CITY OF ALBUQUERQUE

RE: 6008 Tesuque Dr. NW
Grading and Drainage Plan
Engineer's Stamp Date: 04/03/23
Hydrology File: E10D123

ENGINEER'S SEAL DAVID SOULE NEW MEXICO REGISTERED PROFESSIONAL ENGINEER 14522 4/3/23 DAVID SOULE P.E. #14522	Lot 6 Blk 7-A Un 3 VC 6008 TESUQUE DRIVE N.W.	DRAWN BY DEM
	GRADING AND DRAINAGE PLAN	DATE 4-1-23
	Rio Grande Engineering P.O. BOX 53924 ALBUQUERQUE, NM 87199 (505) 321-9099	Lot 6 Blk 7-A Un 3 VC.dwg
SHEET # C1		JOB #

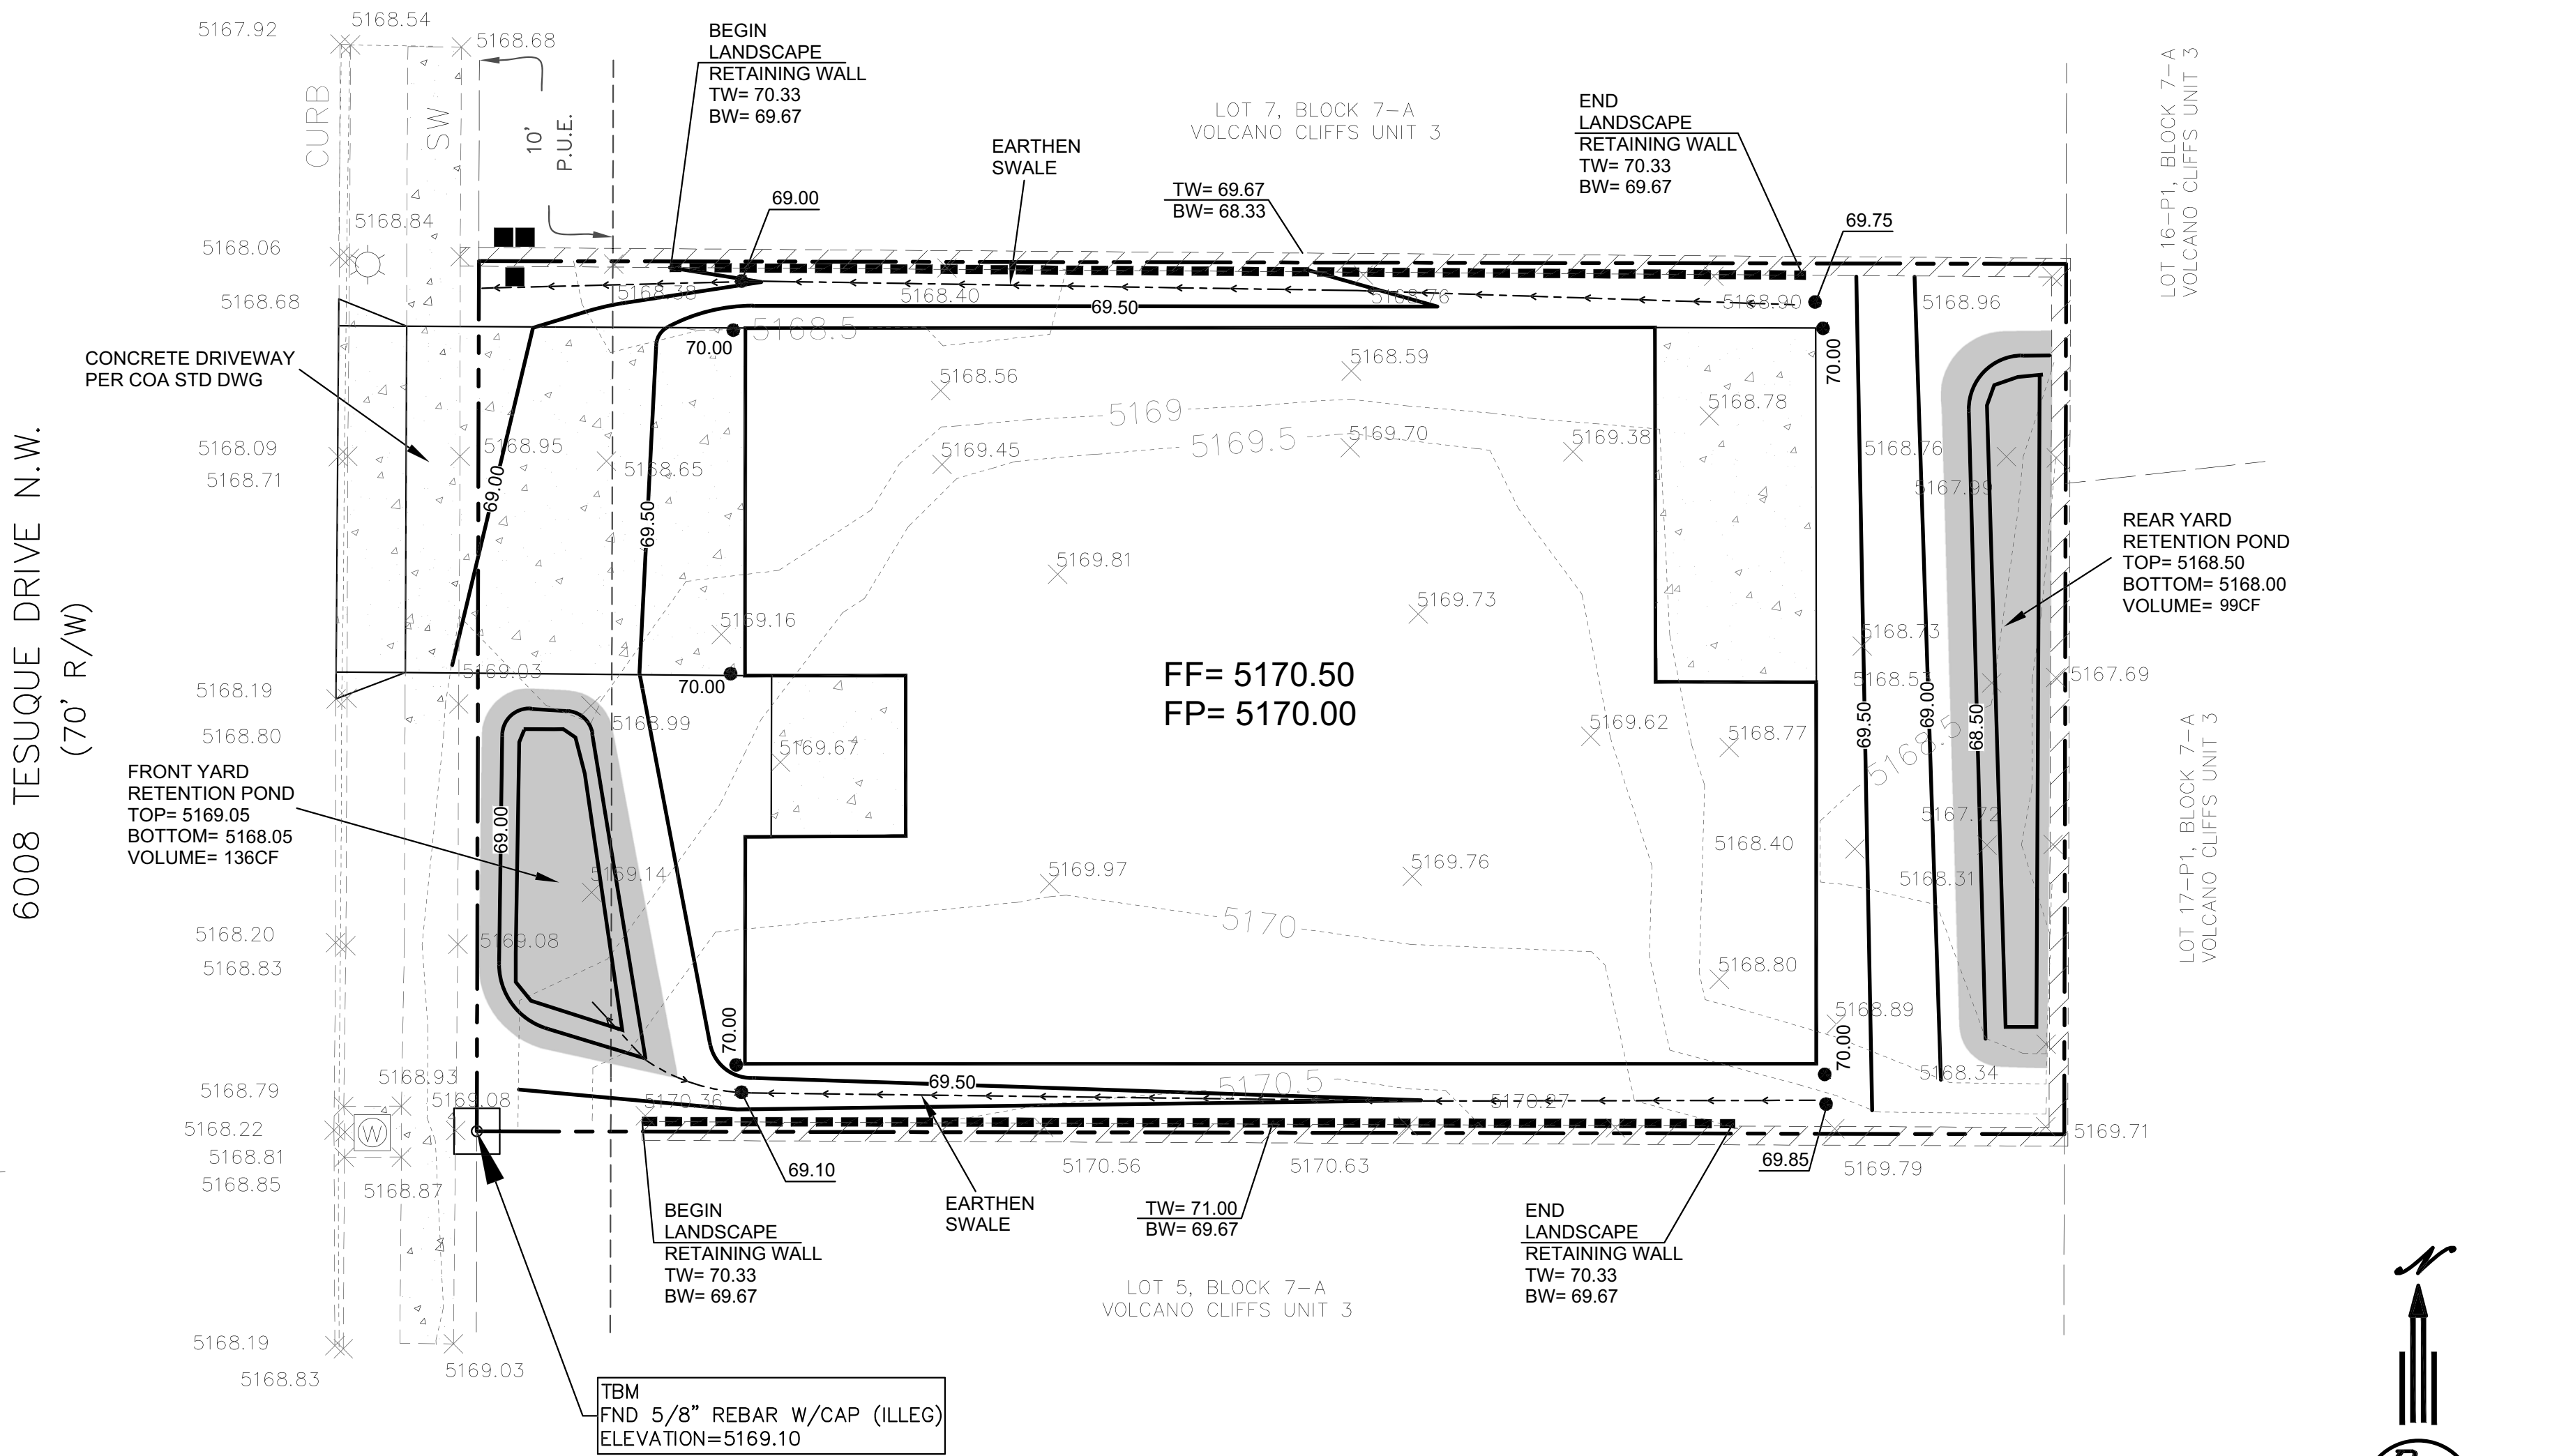
Based upon the information provided in your submittal received 04/03/2023, the Grading and Drainage Plan is approved for Building Permit and Grading Permit. **Since this site is relatively flat and grades to the road, a pad certification is not needed for this project.** Please attach a copy of this approved plan in the construction sets for Building Permit processing along with a copy of this letter.

1. Engineer's Certification, per the DPM Part 6-14 (F): Engineer's Certification Checklist For Non-Subdivision is required.
